**Response to Cabinet Comments on the Herrington Lake  
Corrective Action Investigation, Source Assessment, and Risk Assessment Report**

This document and the attached Addendum (Appendix A, *Corrective Action Investigation Source Assessment, and Risk Assessment [ISARA] Report- Coal Pile Addendum*) provide the responses to the January 31, 2020 Kentucky Energy and Environment Cabinet Department for Environment Protection (Cabinet) comments on the *Corrective Action ISARA Report* for the Kentucky Utilities Company (KU) EW Brown Station.<sup>1</sup> The Cabinet comments are shown in italics followed by the corresponding responses.

By letter dated January 31, 2020, the Cabinet provided comments on the Corrective Action ISARA report. This addendum to the Corrective Action ISARA Report (hereafter referred to as the Coal Pile Addendum) was prepared in response to Comment #4, which requested additional evaluation regarding potential impacts to Herrington Lake from runoff or groundwater infiltration associated with the coal pile and coal pile retention pond.

**COAL PILE AND COAL PILE RETENTION POND, NORTH VIEW**

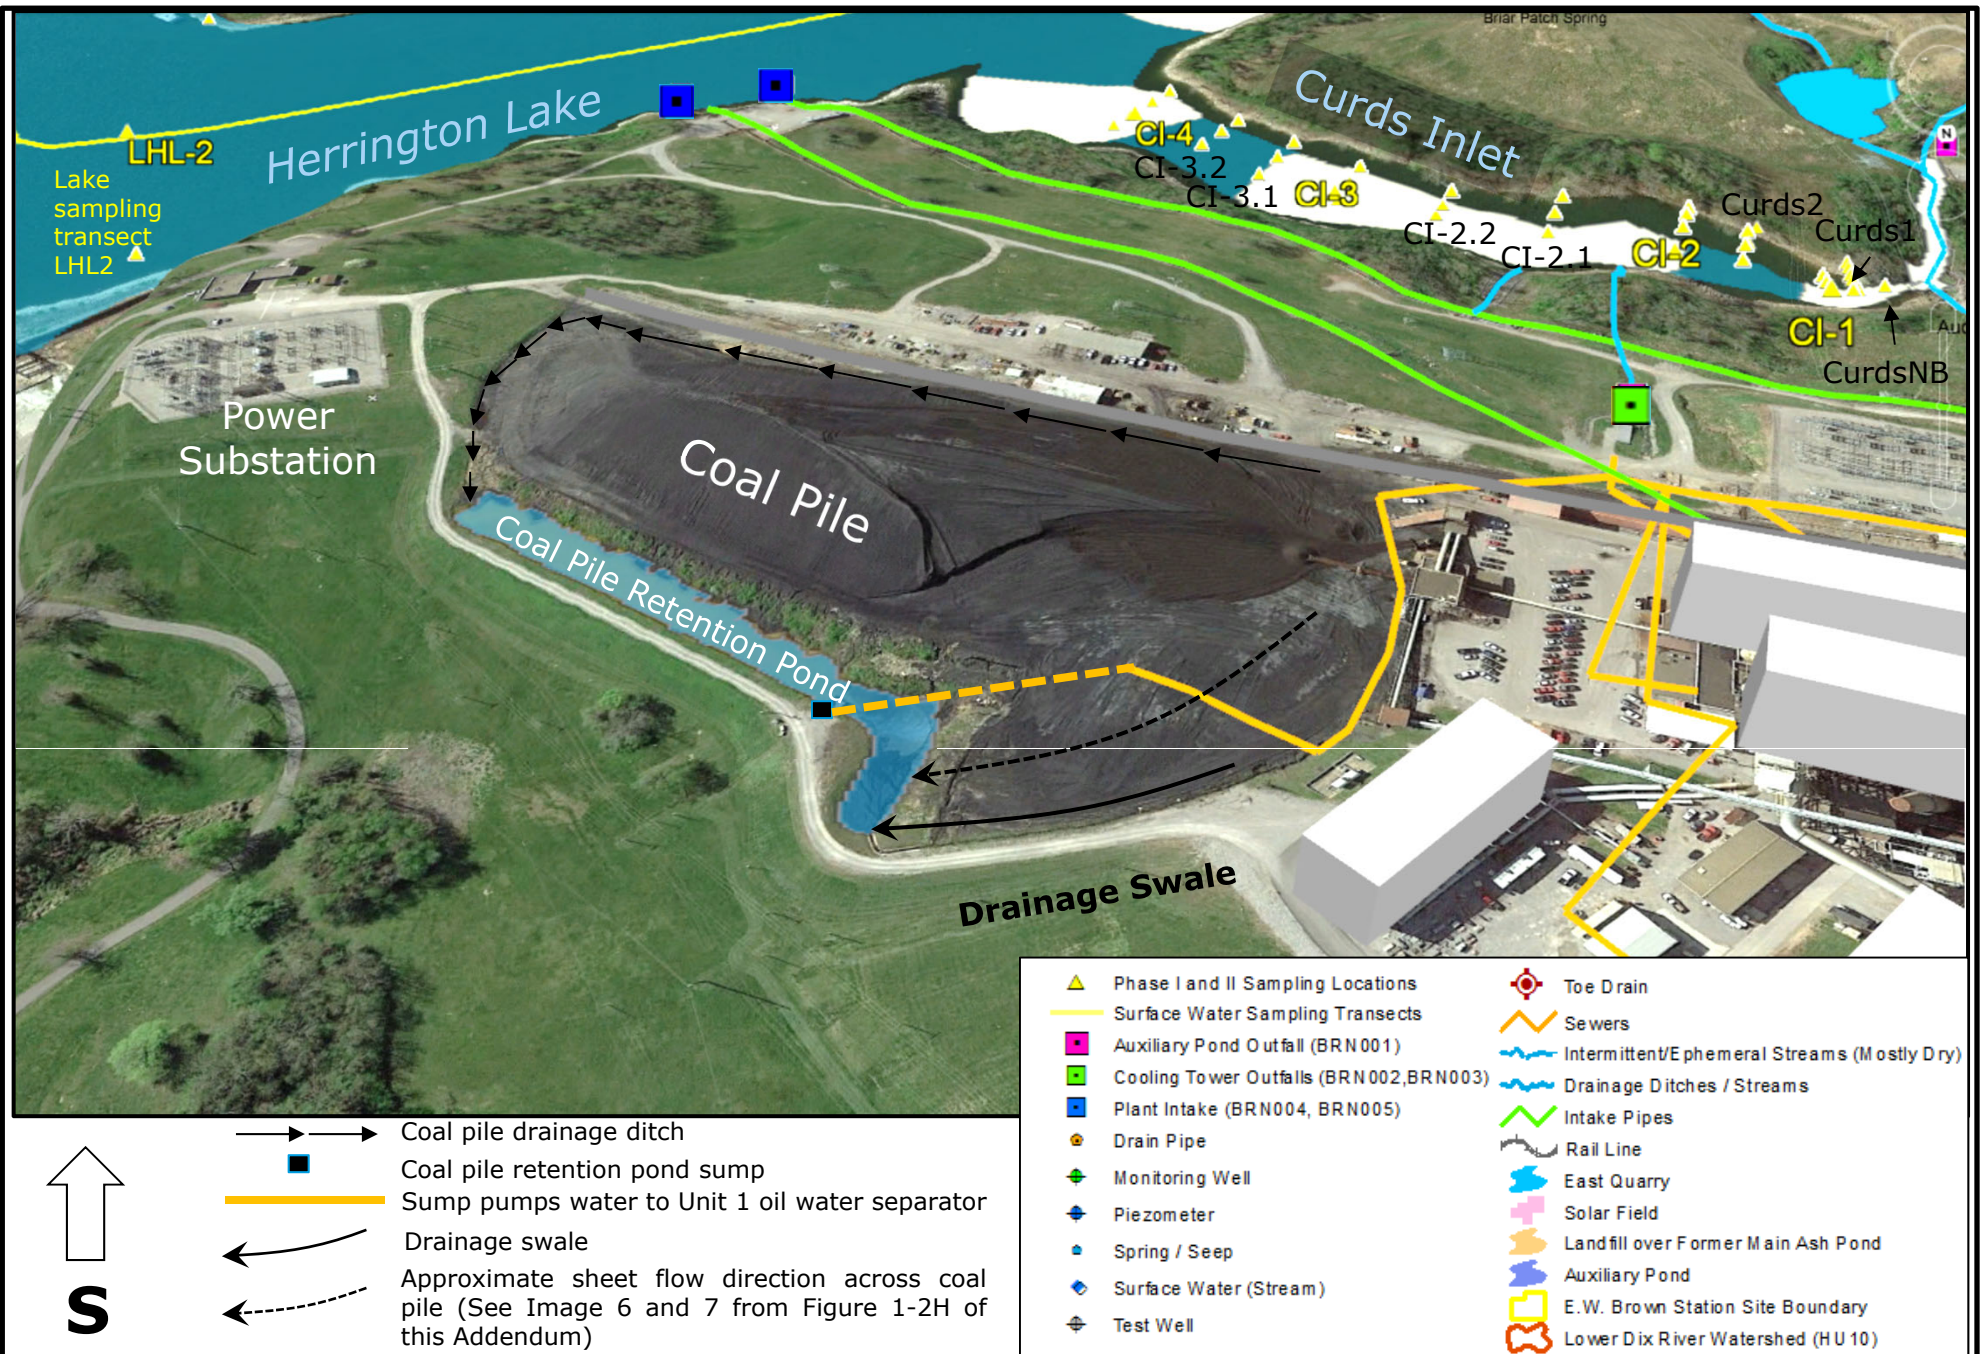
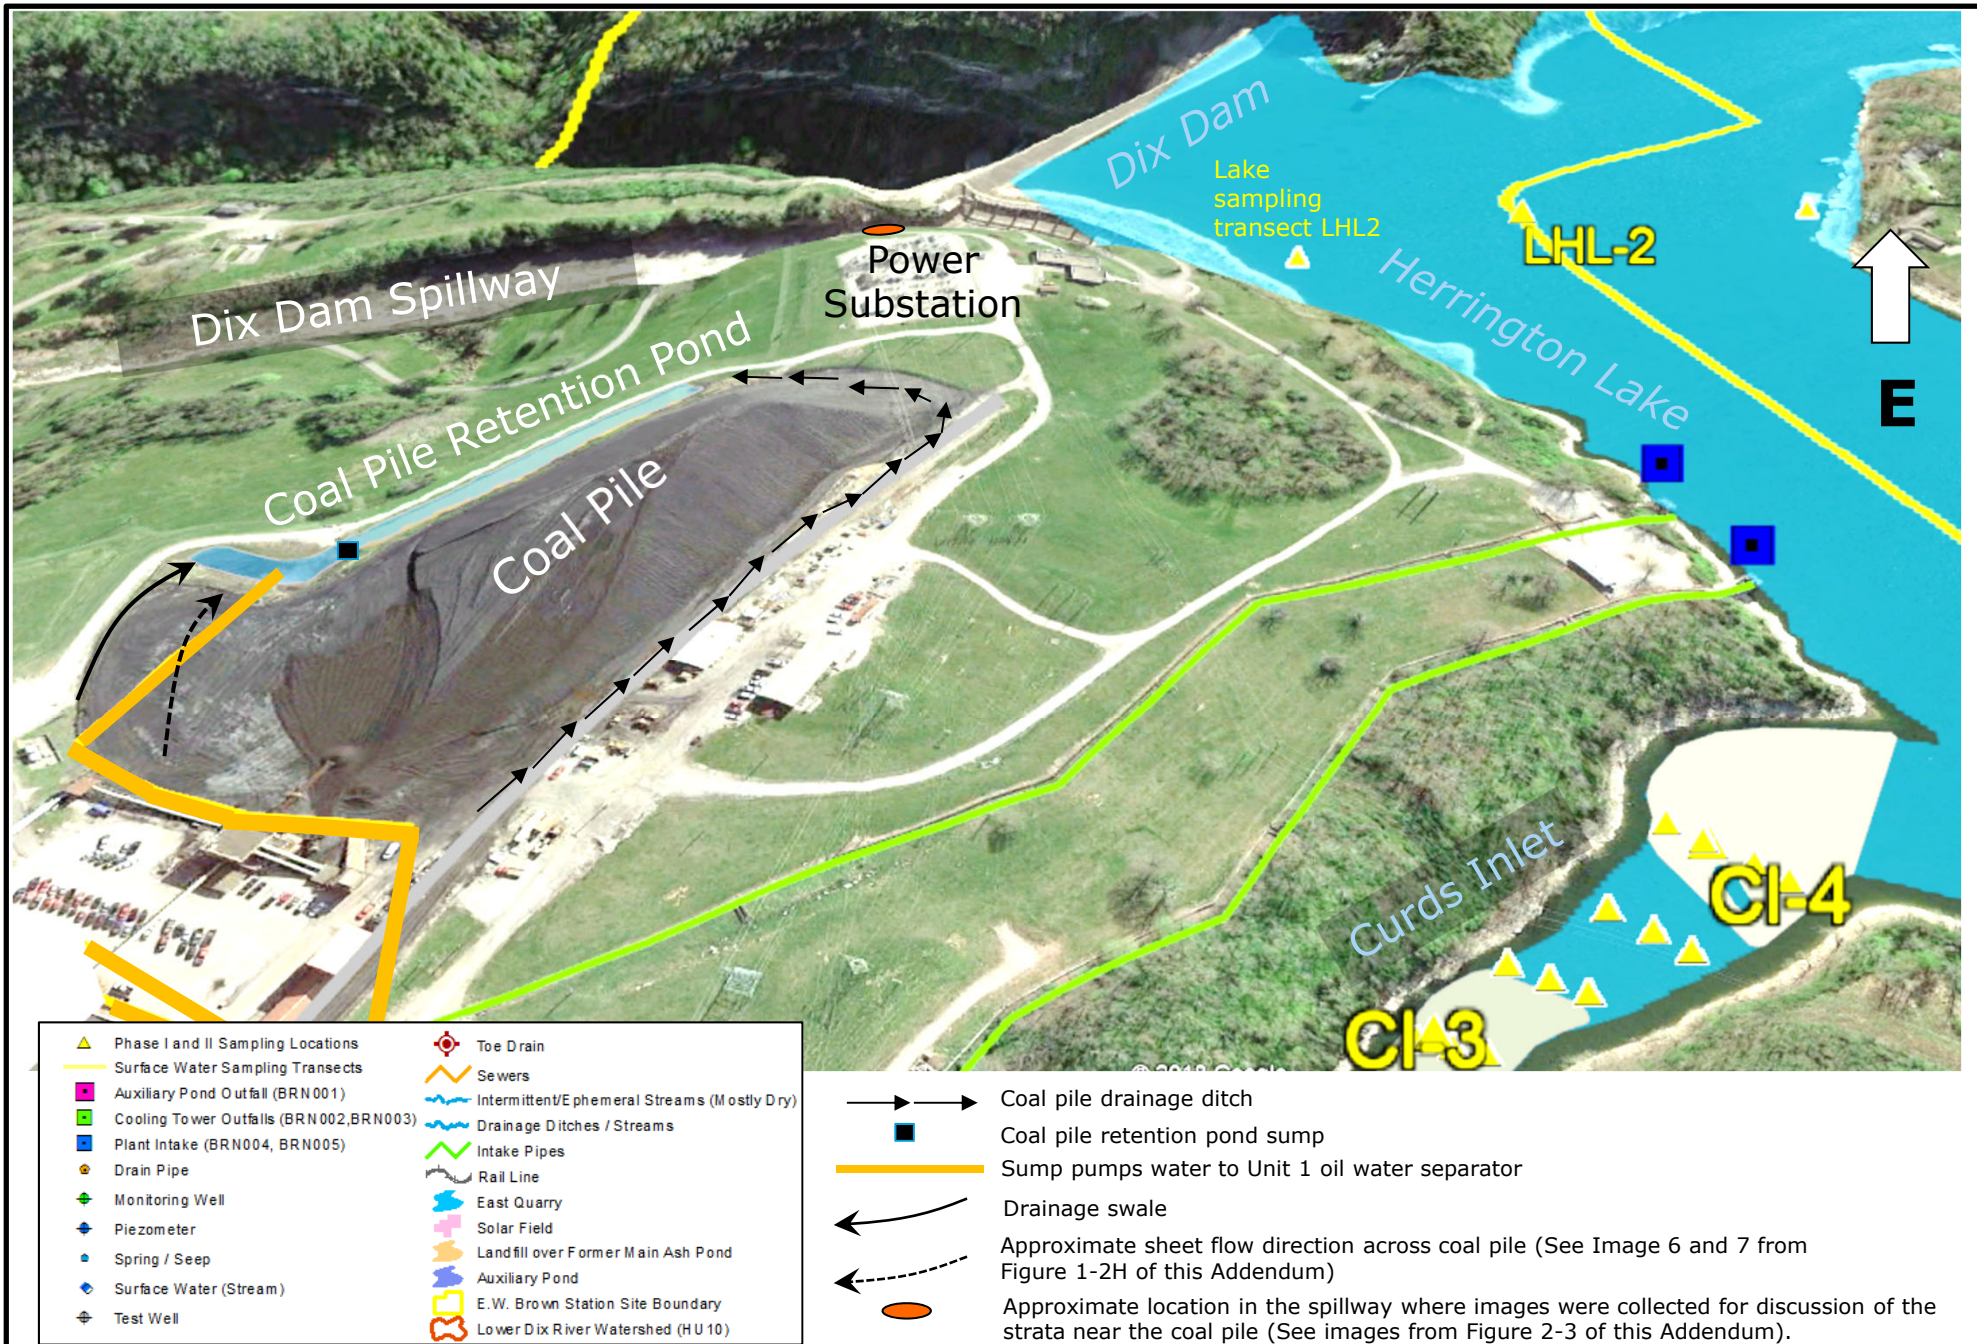
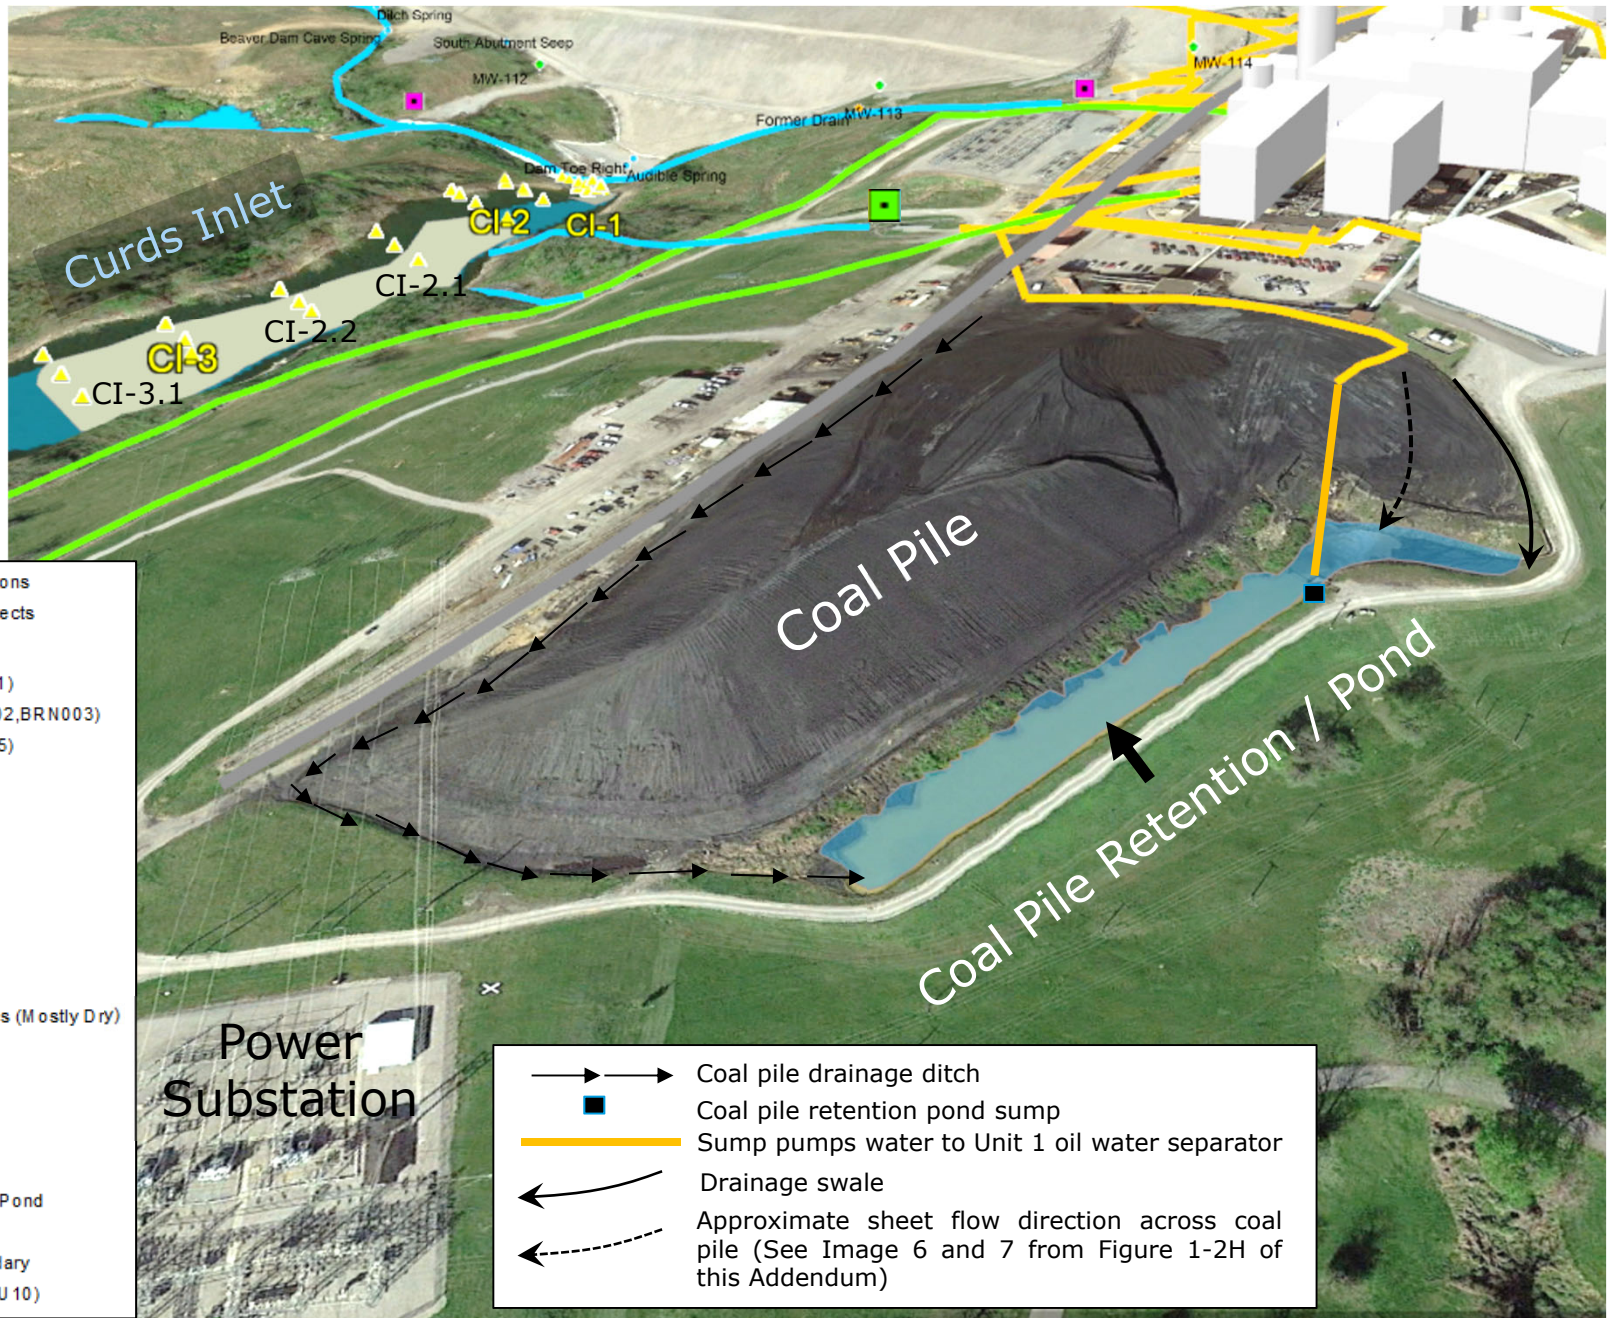
*Section 3.1.1 discusses and Figure 3-1J shows runoff collection for the coal pile along the northern edge of the stored coal. The ISARA asserts that drainage from the coal pile is collected in the coal pile runoff and settling pond. It is, however, unclear whether runoff shedding towards the south, for example, would be captured by this collection system. Additionally, it is unclear whether groundwater infiltration from this area is important to decision making in the SRAA. Ensure all potential runoff from the stored coal is adequately described and the basis of that description documented and presented to support the SRAA. Efforts such as, but not limited to, human reconnaissance of the area and drone or remote sensing photography of potential flow paths may be useful. Please provide a response in the errata.*

An addendum to the Corrective Action ISARA Report is provided in an Appendix to these responses (Appendix A) to address the coal pile and the coal pile retention pond as potential sources of coal-related constituents to Herrington Lake. This Coal Pile Addendum provides additional background information for the coal pile and the coal pile retention pond, describing:

- The location of the coal pile and coal pile retention pond relative to Herrington Lake.
- The geological and hydrogeological setting, which explains the conceptual model for how water from beneath the pond would migrate to the lake.
- An assessment of potential mass loading for selenium and arsenic in any seepage to Herrington Lake.

- A comparison of the coal-related constituent concentrations in the coal pile retention pond water, as a surrogate for potential exposure point concentrations, to water quality criteria for the protection of human health and the environment, and an evaluation of constituent concentrations in the lake at sampling locations closest to the coal pile.

The Coal Pile Addendum provided in the Appendix A concludes that there is no indication that coal-related constituents are migrating to Herrington Lake due to possible seepage to groundwater from the coal pile or the coal pile retention pond at concentrations or loadings that would pose an unacceptable risk to the environment or human health.
